Consultee Comments - Urban Design

Consultee:	BNE – Urban Design
Reference Number:	23/03204/OUT
Proposal:	Outline application (with all matters reserved) for the demolition of existing buildings and structures and redevelopment of the site for a new local centre (E (a-f), F1(b-f), F2(b,d)), open space and employment (office and laboratory) floorspace (E(g)(i)(ii) to the ground floor and employment floorspace (office and laboratory) (E(g)(i)(ii) to the upper floors, along with supporting infrastructure, including pedestrian and cycle routes, vehicular access, car and cycle parking, servicing areas, landscaping and utilities. (The Development is the subject of an Environmental Impact Assessment)
Site Address:	Beehive Centre Coldham's Lane Cambridge CB1 3ET Cambridgeshire
Case Officer:	Cuma Ahmet
Responding Officer:	Sarah Chubb
Date:	09.11.23

Proposed outline application – Castle Hill

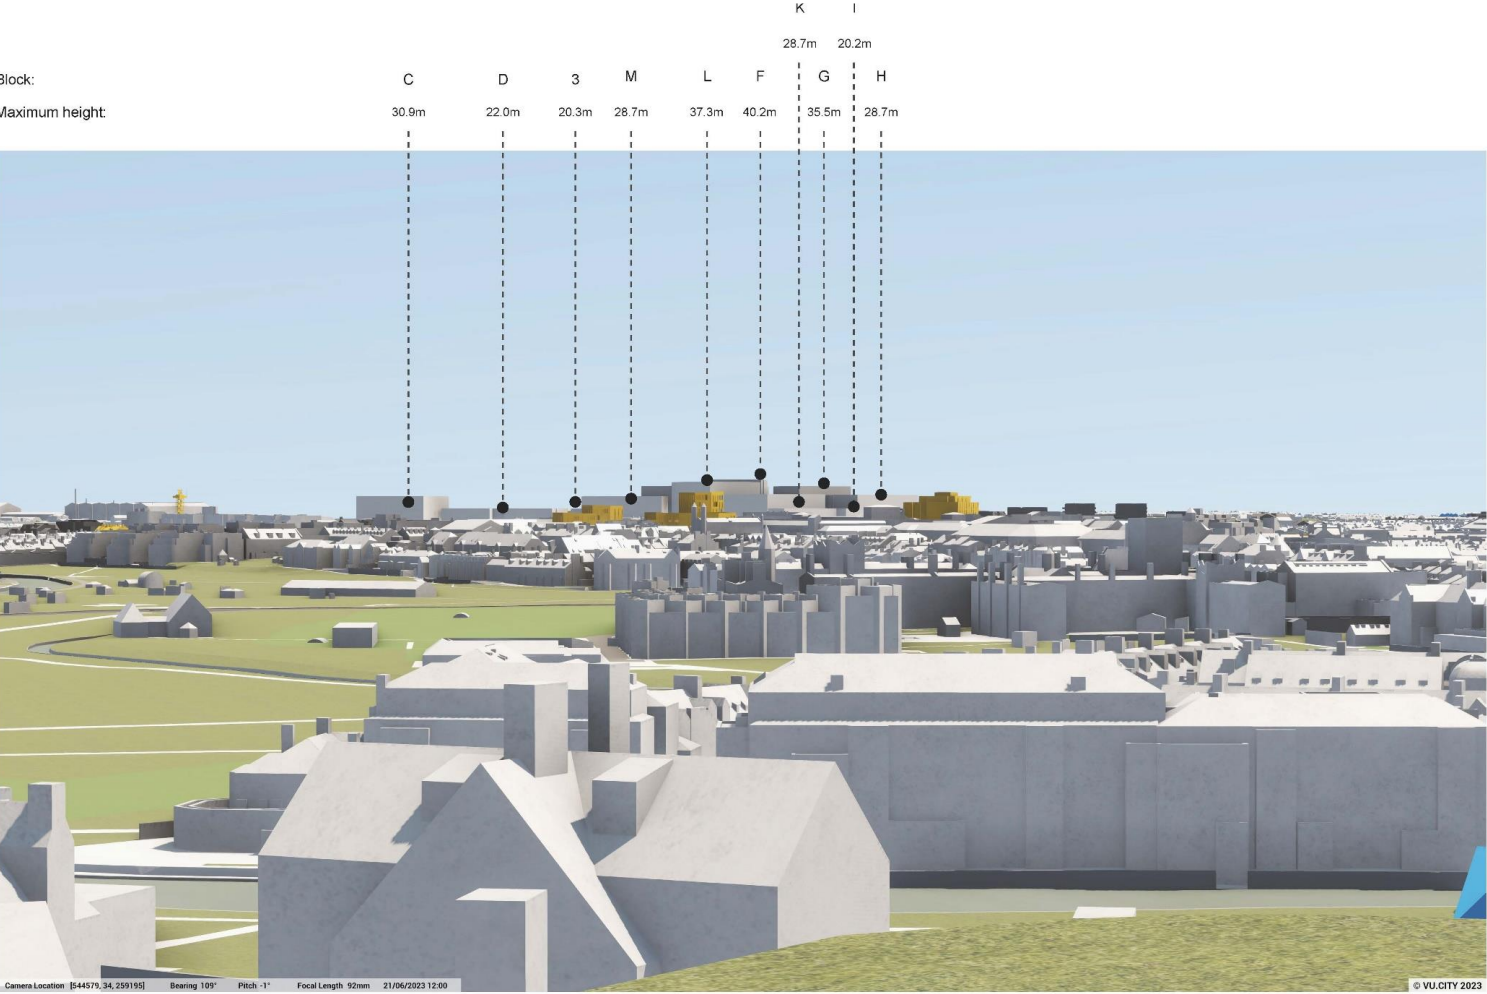
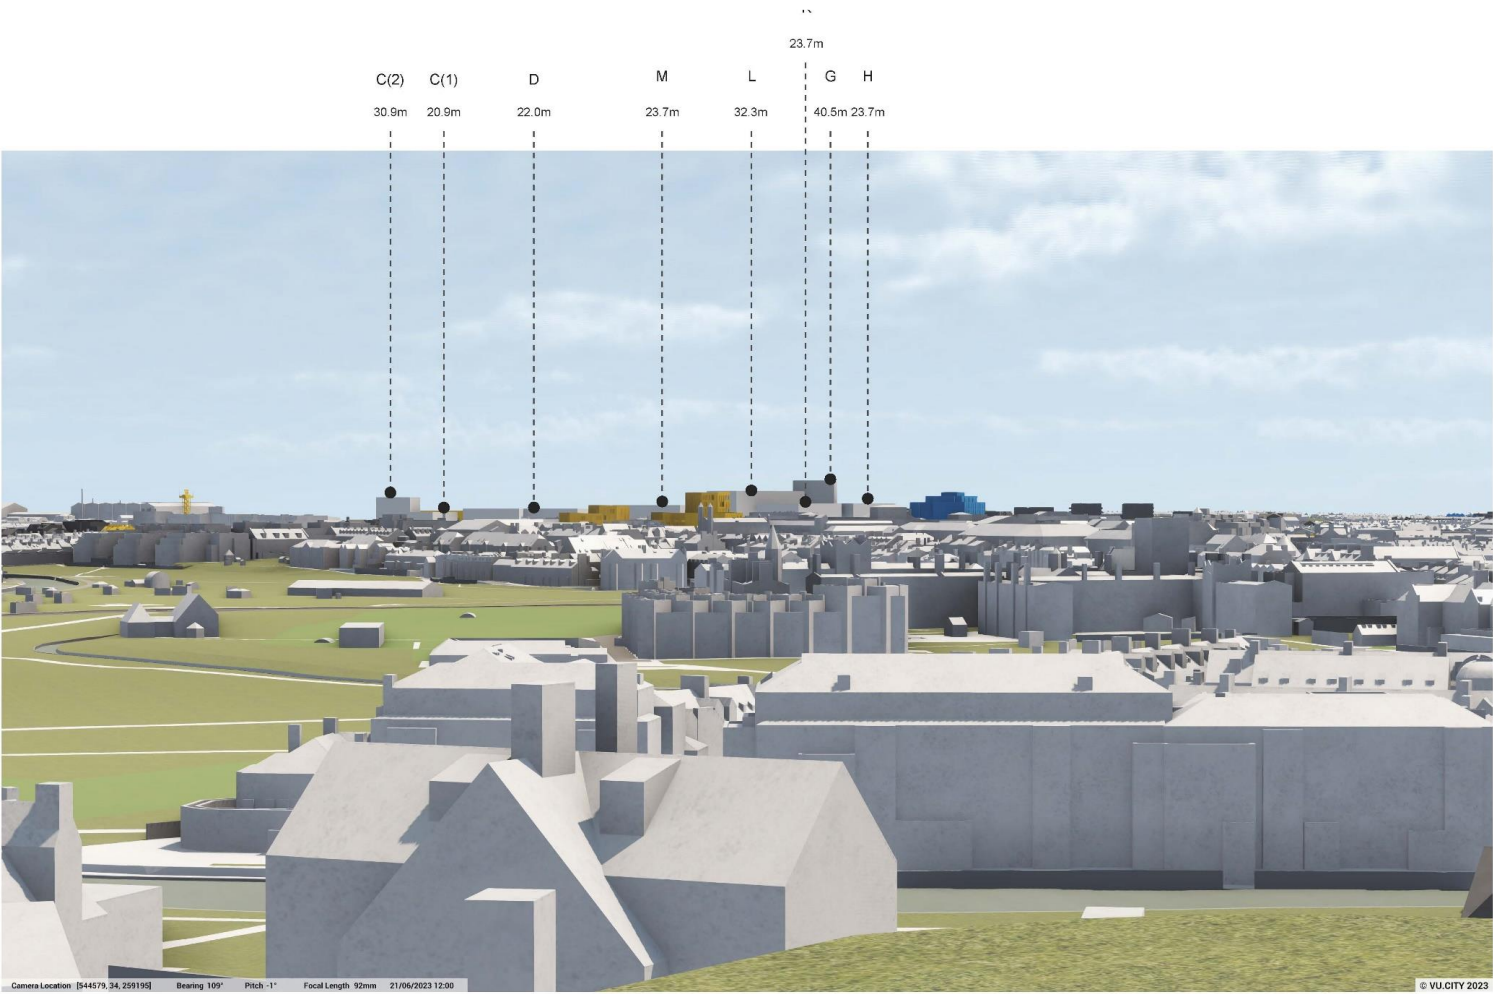
The following pages set out an alternative approach for reorganising and re-imagining the site in a way to respond positively to our concerns, other technical consultees and the community. The suggested layout and massing strategies are given without prejudice, providing alternative concepts and approaches for further design development and testing through verified views, including additional viewpoints from the rear gardens of existing residential properties.

Proposed outline application – York Street / Sleaford Street

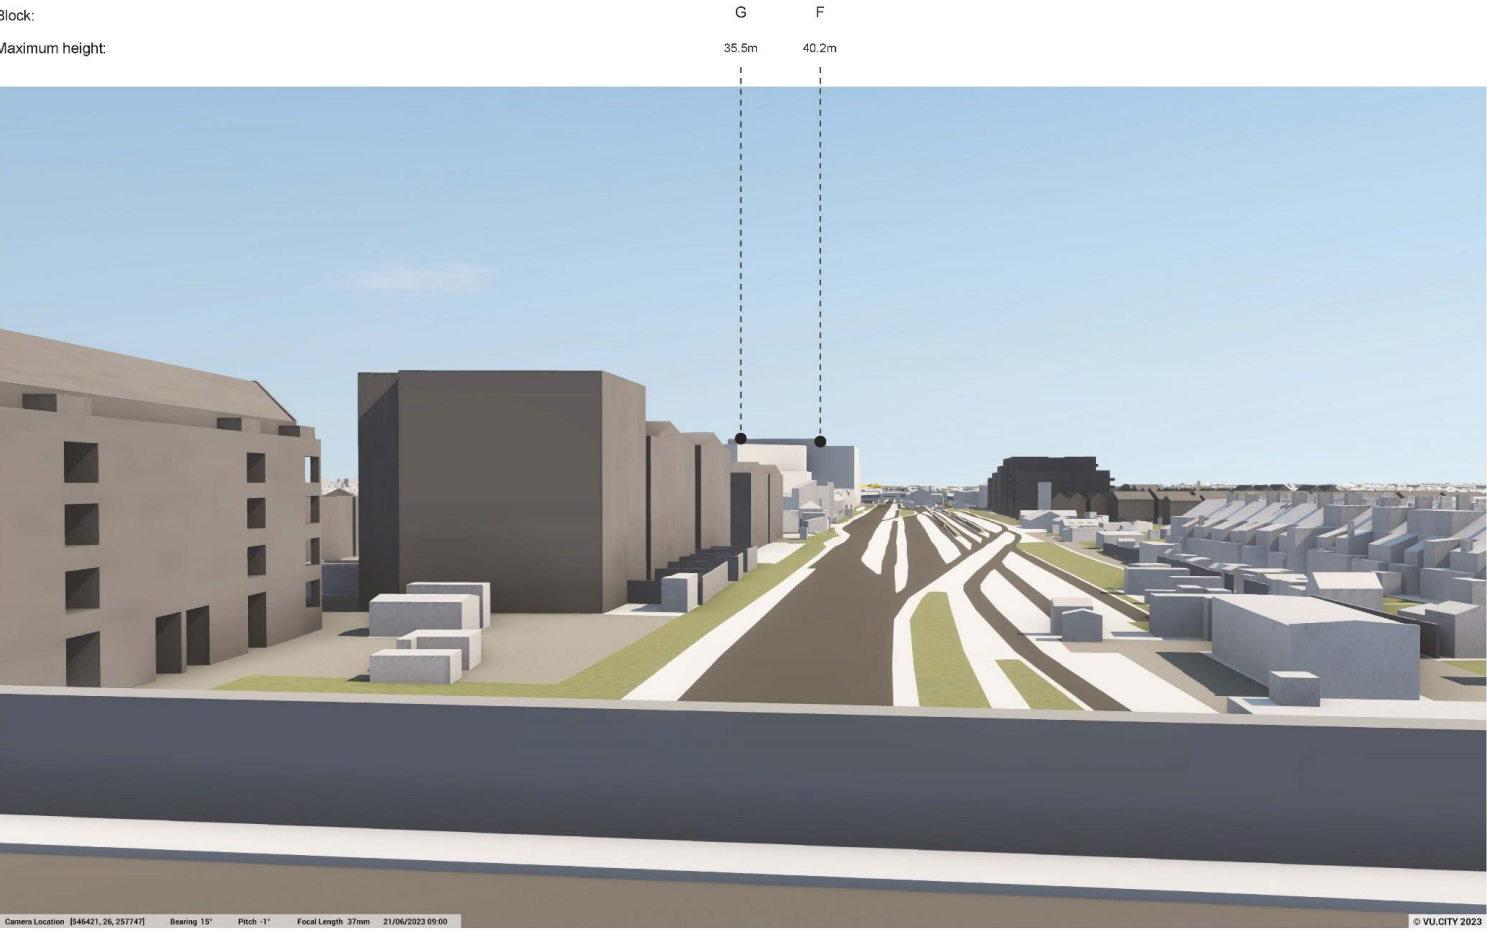
The proposed scale of the plots that line the railway are also problematic from corner of Sleaford Street (view 04). From this view, the massing volumes of Plots H and G coalesce above the trees striking an overly horizontal emphasis in a finger grain context of the conservation area, where vertical proportions and rhythms predominate and roofscape notches form a key characteristic.
